CONTRACT CHANGE ORDER MEMORANDUM

TO: DEANNA VILCHECK / JEANNETTE BALDERRAMOS			FILE: E.A. 04 - 0120M4
FROM: JEANNETTE BALDERRAMOS			CO-RTE-PM 04-ALA-80-1.6/2.7
			FED. NO. NO FED AID
CCO#	SUPPLEMENT#:	Category Code:	CONTINGENCY BALANCE (incl. this change)
1	0	AJZZ	\$5,079,361.00
COST: \$250,000.00		INCREASE <input checked="" type="checkbox"/> DECREASE <input type="checkbox"/>	HEADQUARTERS APPROVAL REQUIRED? <input type="checkbox"/> YES <input checked="" type="checkbox"/> NO
SUPPLEMENTAL FUNDS PROVIDED: \$250,000.00		IS THIS REQUEST IN ACCORDANCE WITH ENVIRONMENTAL DOCUMENTS? <input checked="" type="checkbox"/> YES <input type="checkbox"/> NO	
CCO DESCRIPTION: Flagging & Traffic Control			PROJECT DESCRIPTION: CONSTRUCT BRIDGES AND ROADWAY, AND ELECTRICAL SYSTEM
Original Contract Time:	Time Adj. This Change:	Previously Approved CCO Time Adjustments:	Percentage Time Adjusted: (including this change)
1140 Day(s)	0 Day(s)	0 Day(s)	0 %

CCO DESCRIPTION: Dispute Review Board (Caltrans Portion)		PROJECT DESCRIPTION: CONSTRUCT BRIDGES AND ROADWAY, AND ELECTRICAL SYSTEM		
Original Contract Time: 1140 Day(s)	Time Adj. This Change: 0 Day(s)	Previously Approved CCO Time Adjustments: 0 Day(s)	P

REVISED BY
 DATE REVISED

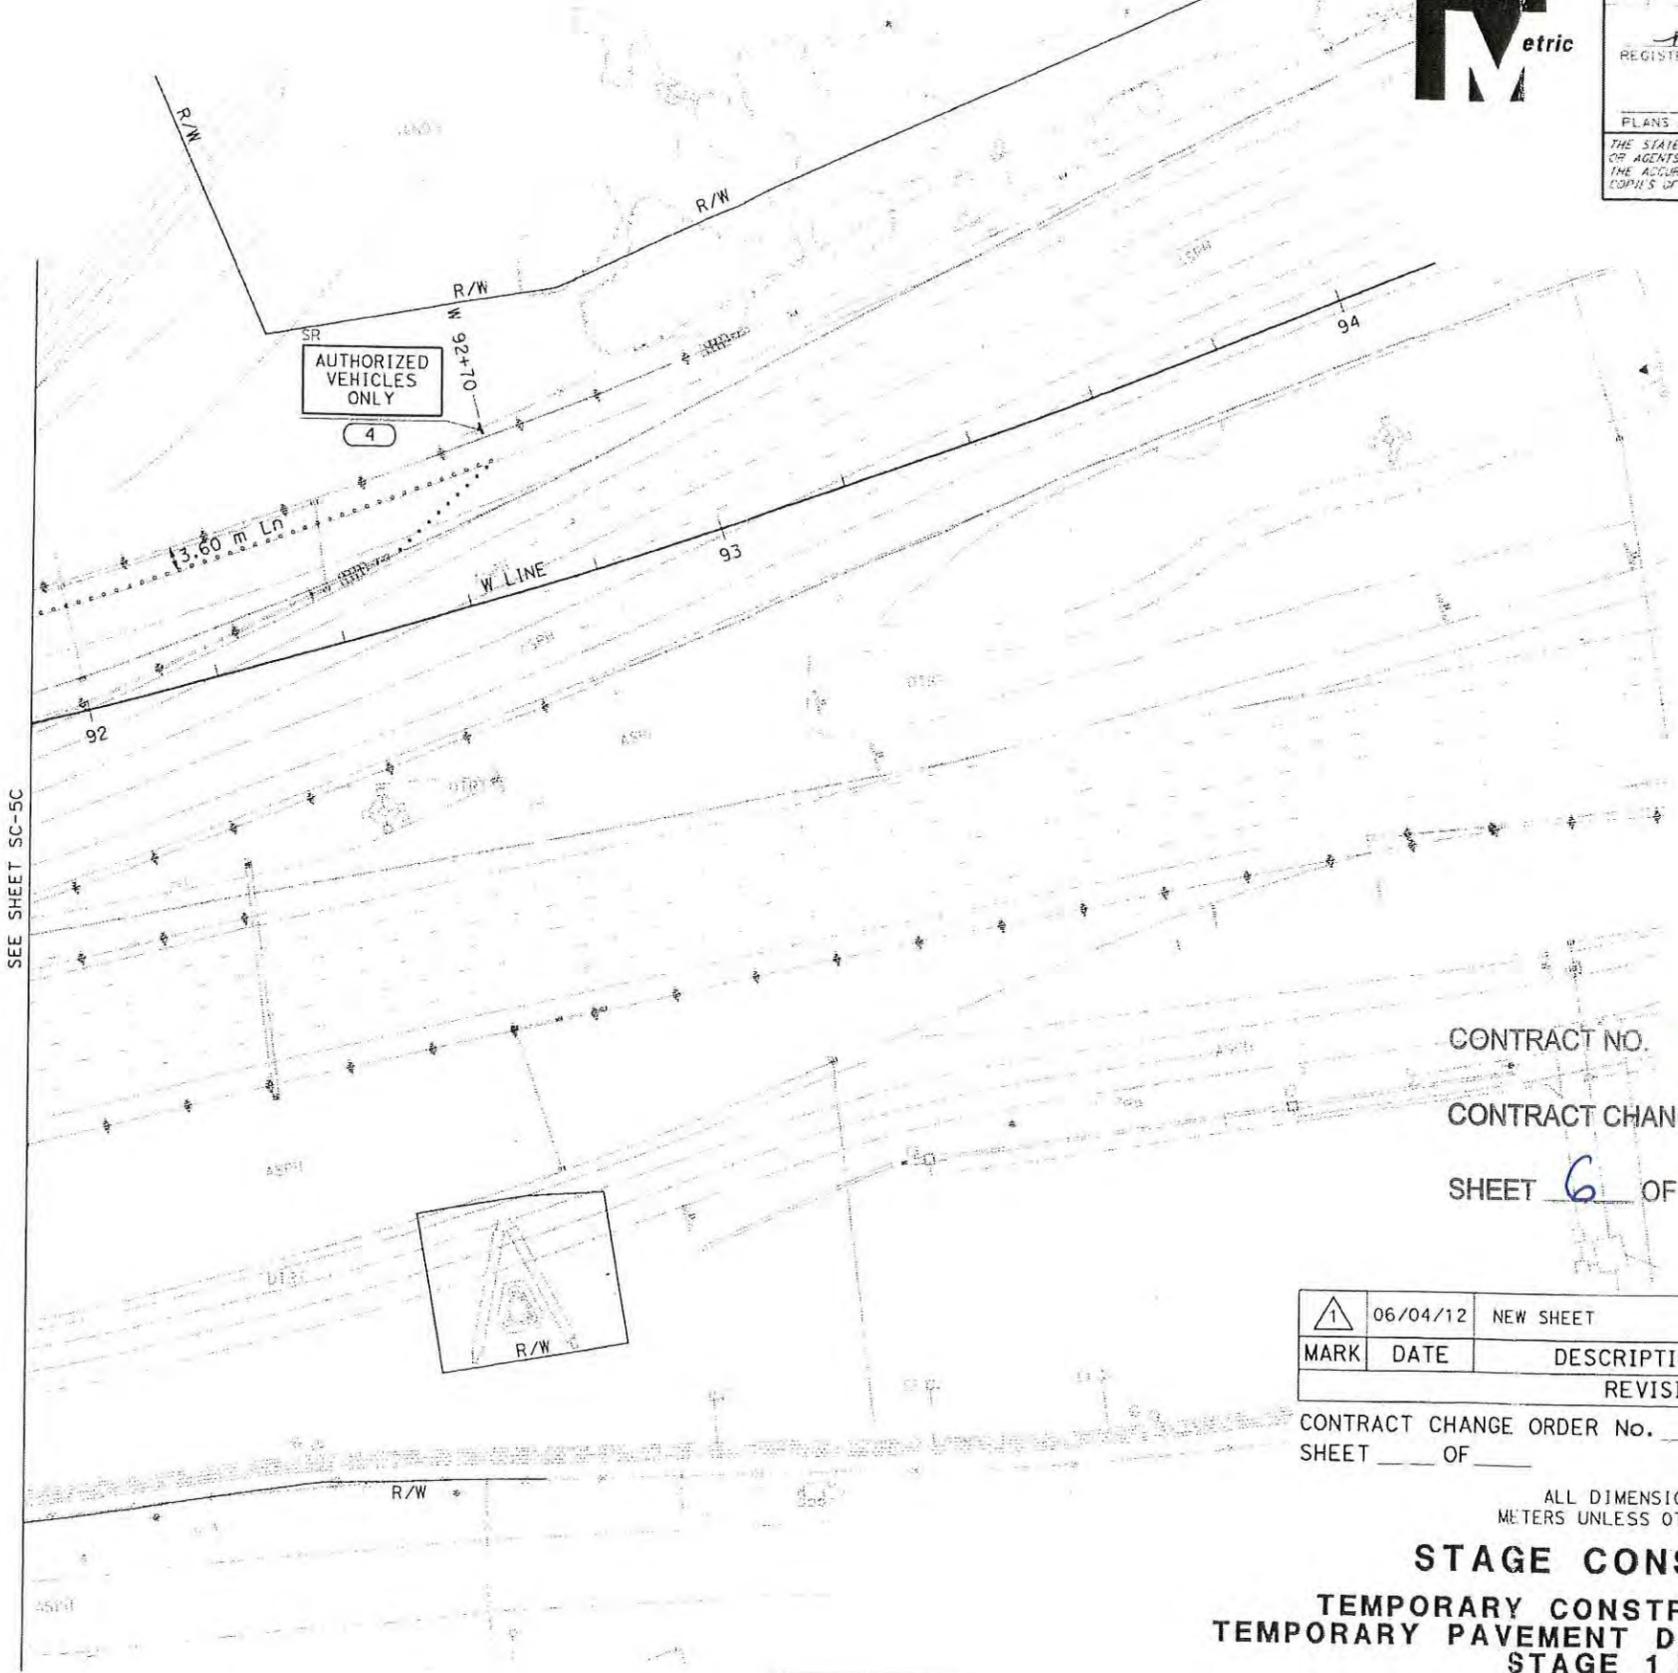
Construct the access merge lane from the construction site to Westbound I-80, as shown on contract plan sheets 110A, 110B, 110C, 110D, and 131R1, sheets 3 through 7 of this change order.

04-0120M4
 SUPPLEMENTAL SHEET
 CONTRACT CHANGE ORDER NO. 36
 SHEET 2 OF 2

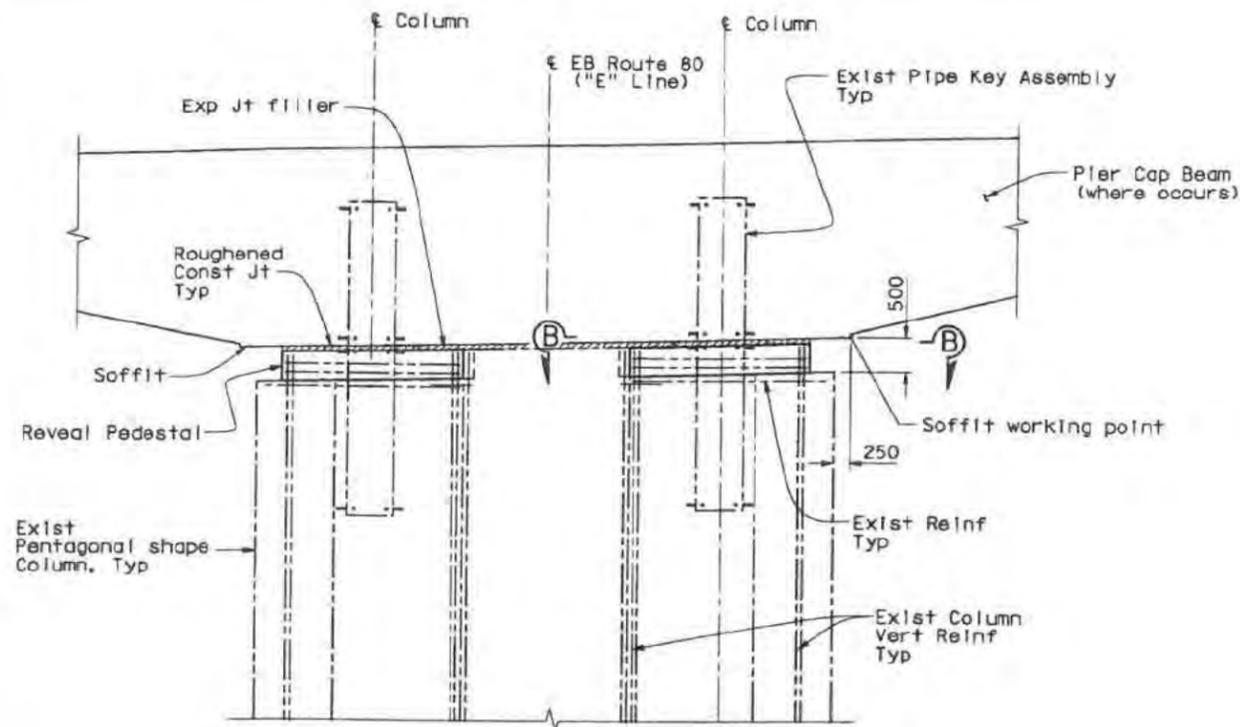
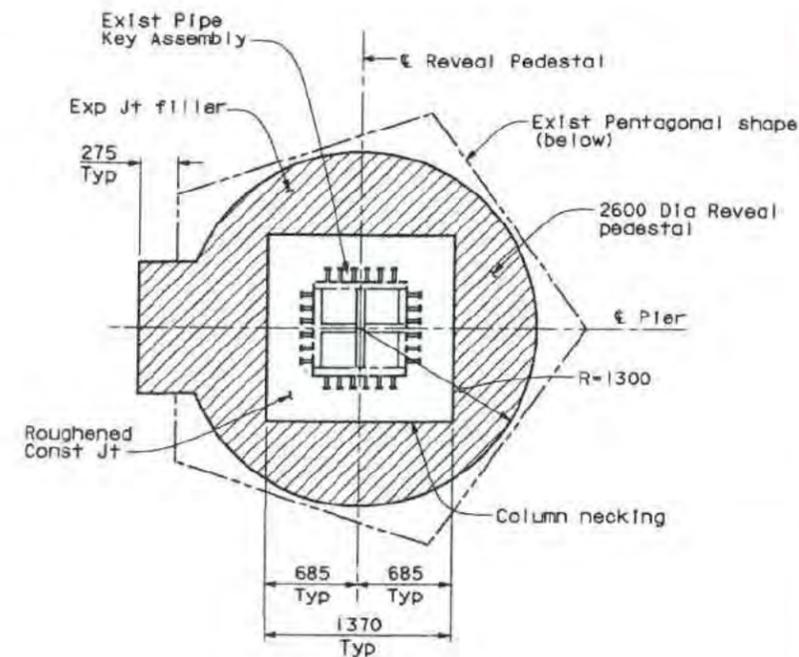
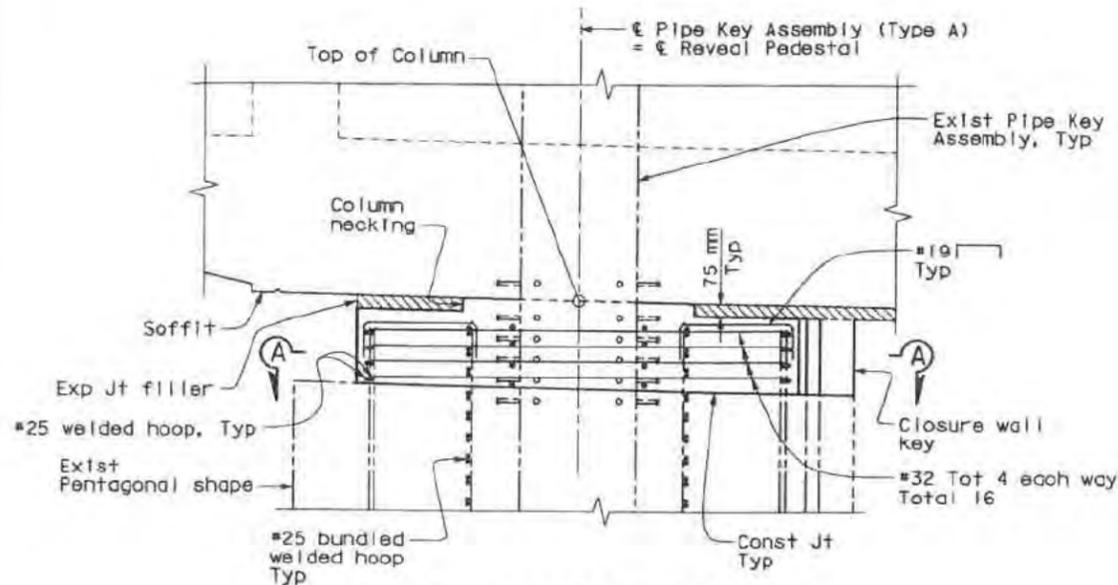
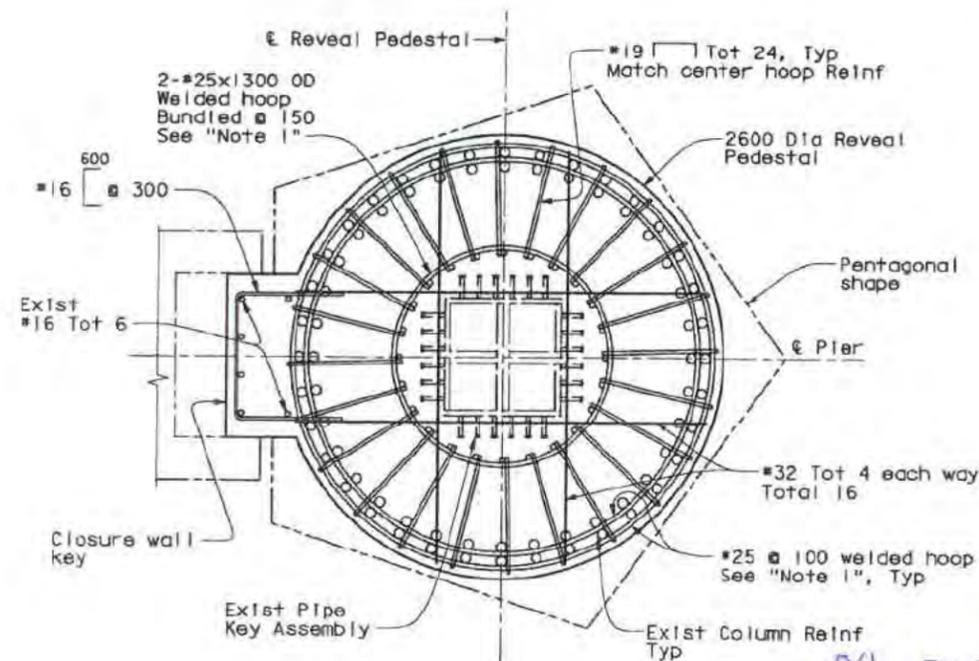
Construct concrete reveal pedestals and keys at Piers E20R, E21R & E22R as shown on Sheet 608AS/744, Eastbound Piers Details No. 7A.
